SUBJECT: ST. LUCIE UNIT 1 - ISSUANCE OF AMENDMENT RE: DELETION OF TOTAL
PLANAR RADIAL PEAKING FACTOR

AMENDMENT NO. 109 TO FACILITY OPERATING LICENSE NO. DPR-67 - ST. LUCIE, UNIT 1

ATTACHMENT TO LICENSE AMENDMENT NO. 109
TO FACILITY OPERATING LICENSE NO. DPR-67
DOCKET NO. 50-335

SAFETY EVALUATION BY THE OFFICE OF NUCLEAR REACTOR REGULATION

FIGURE 3.2-3
Allowable Combinations Of Thermal Power And F_r^T

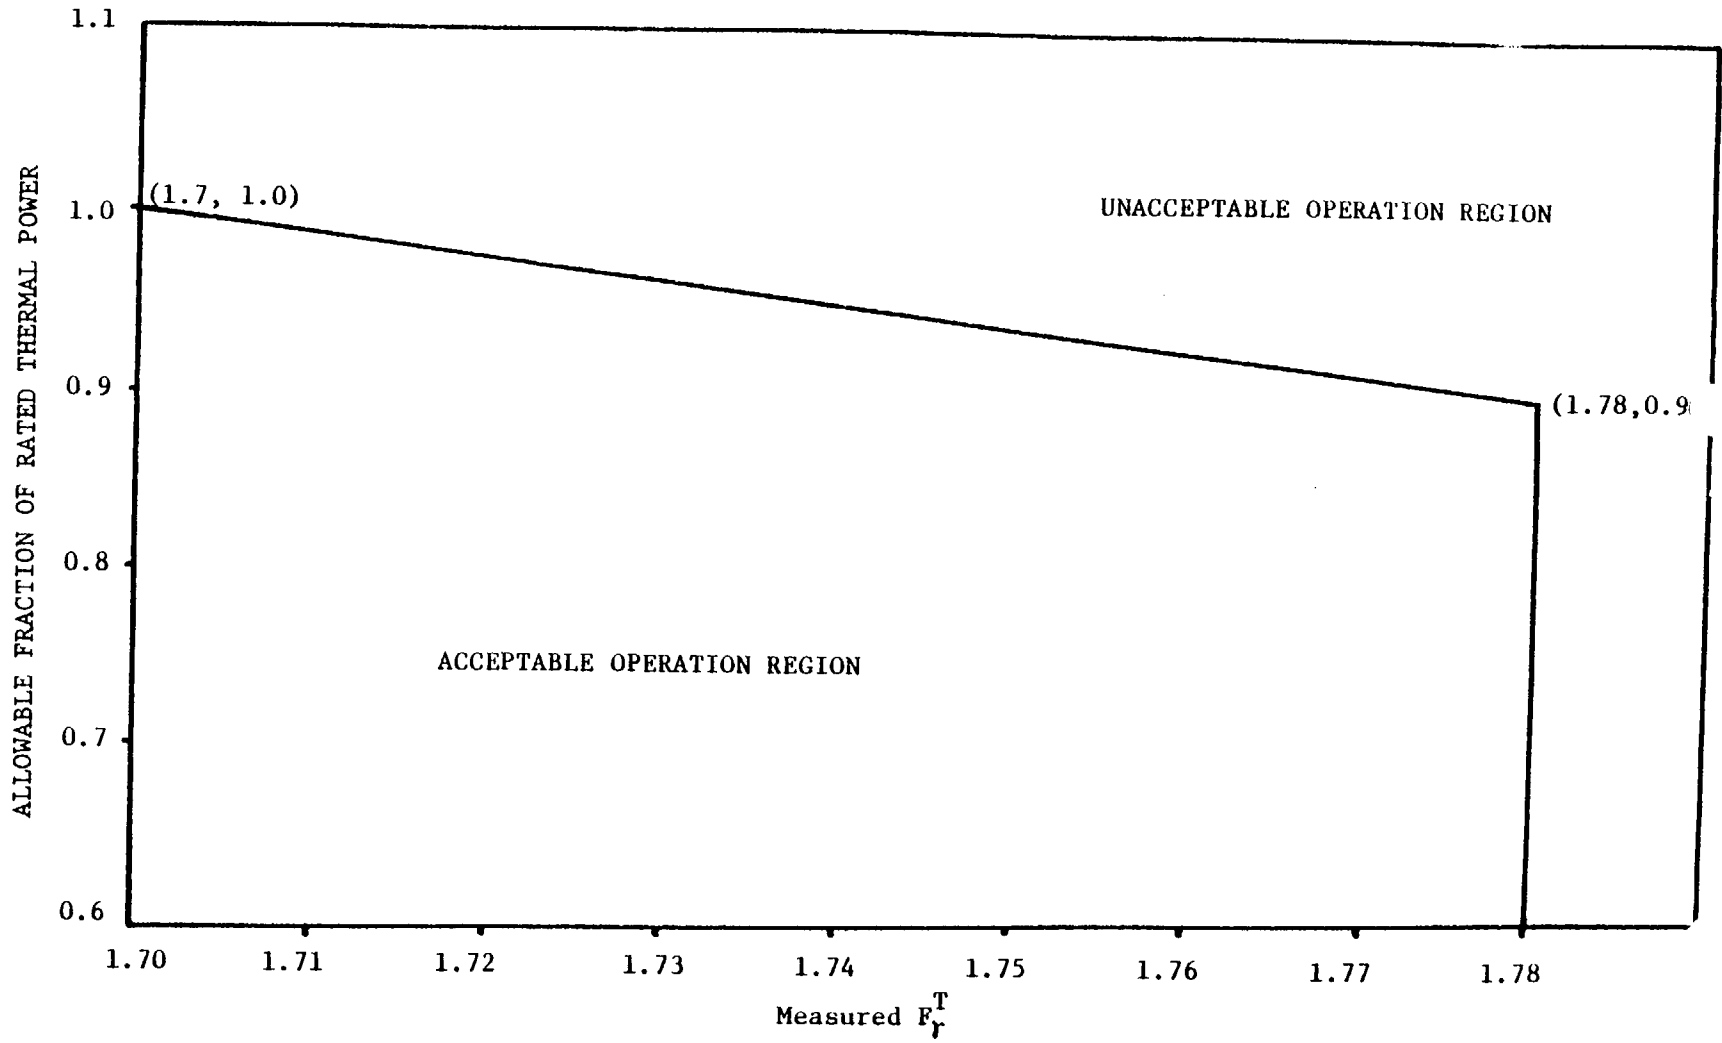
DELETED
